Lariz Fashion Limited

18 May 2022

Buildings Information

1. Factory Building (B+G+9)

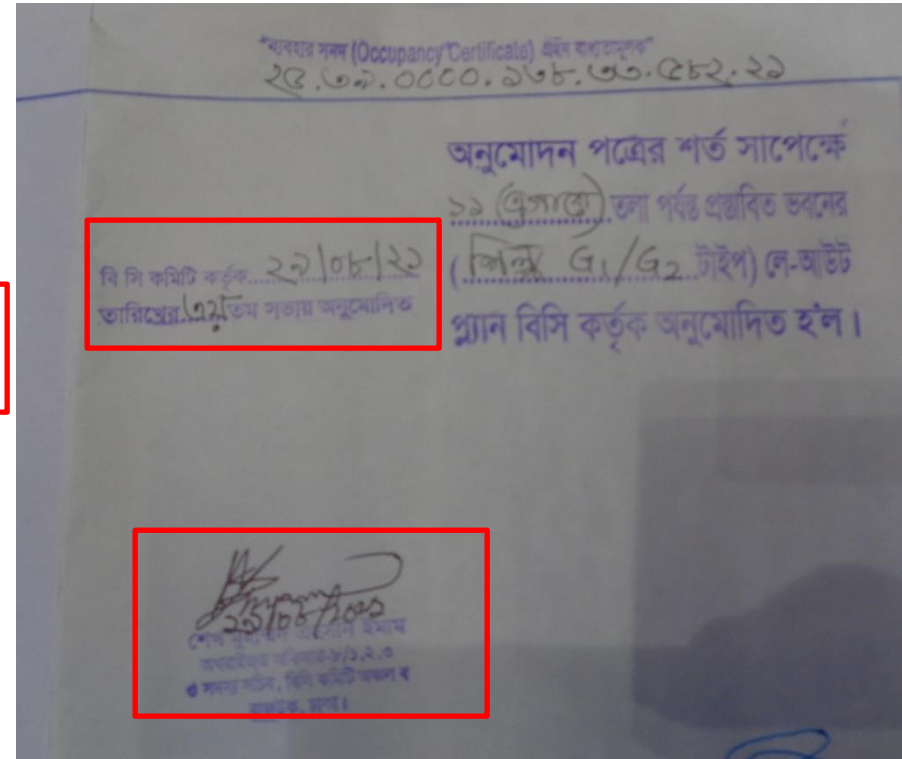
Design code consideration for the existing building

The permit drawing of building was approved on 29 August 2021 (after 11 February 2021, publication date of BNBC 2020) but Engineering Assessment Report for this building is prepared as per BNBC-2006. Factory engineer is required to prepare the design code according to the BNBC 2020 provision and requirements.

3RD TO 10TH FLOOR SLAB REINFORCEMENT DETAILS.
SLAB THICKNESS=8"

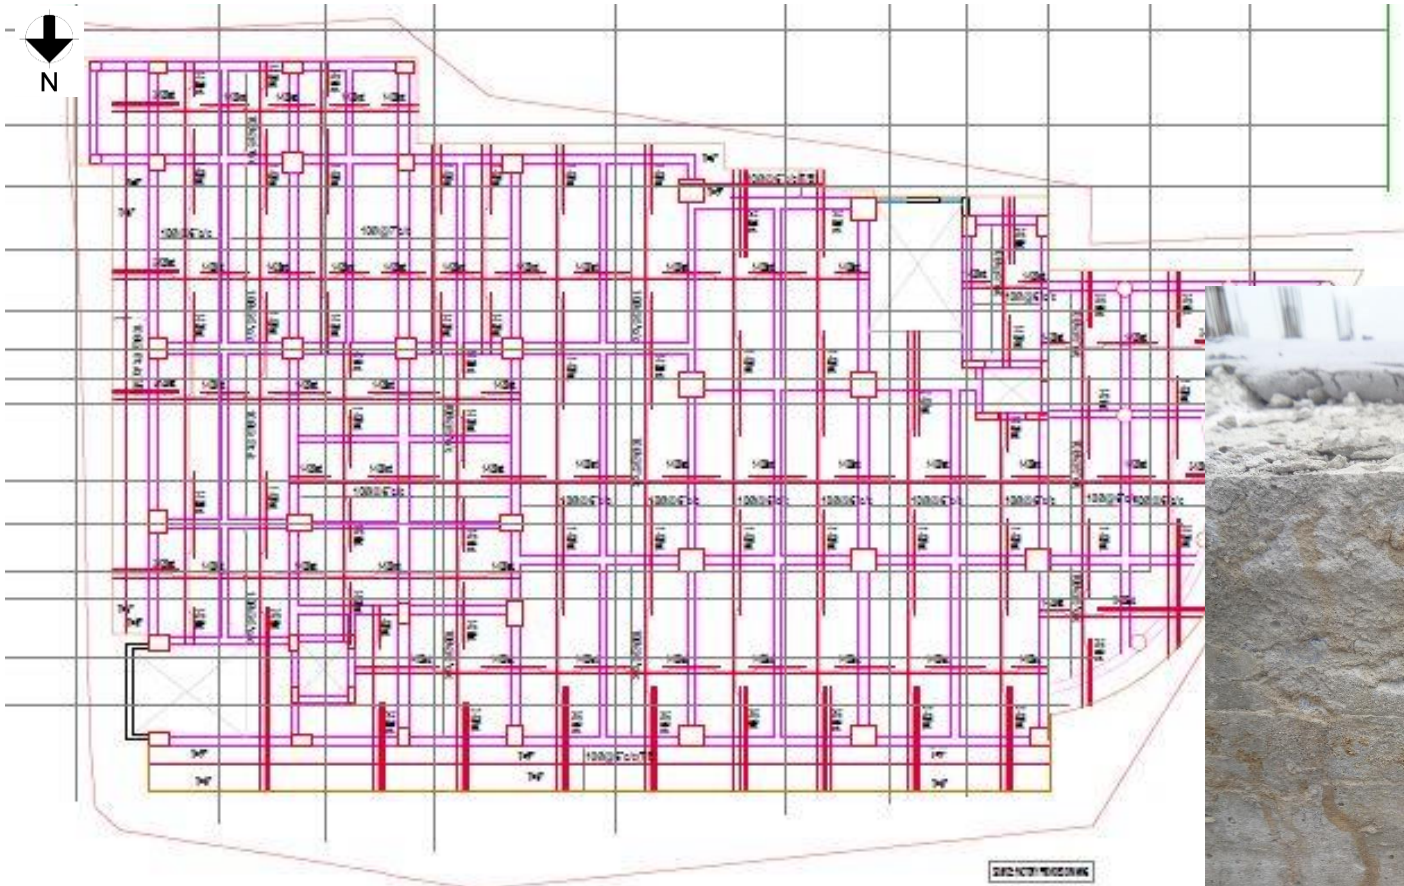
Slab thickness mentioned as 200 mm in provided drawing

Slab thickness measured as 150 mm on site

Slab thickness mentioned as 200 mm in provided drawing
 Factory engineer is required to survey the whole structure and update the as-built drawing as per onsite condition. Also, check the slab adequacy for original thickness.
